The image below offers an aerial perspective of Lingards Road; from Manchester Road on the left.

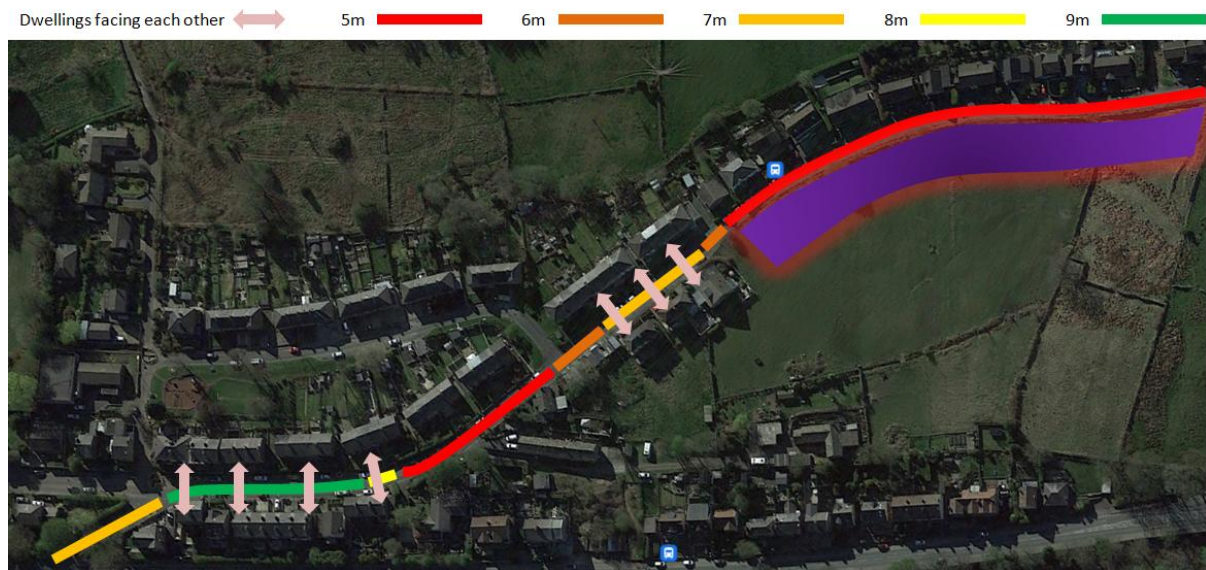
The colours denote the road width along its length.

The arrows denote sections where dwellings face each other.

You will note the road width is greater where dwellings face each other.

Where they do not face each other the road width is narrower.

As you can imagine, pinch points exist where the road width is narrower.

This impacts on traffic movement, when vehicles travelling in opposite directions are sometimes forced to negotiate past each other.

This happens too with horses and cyclists, with on coming vehicles.
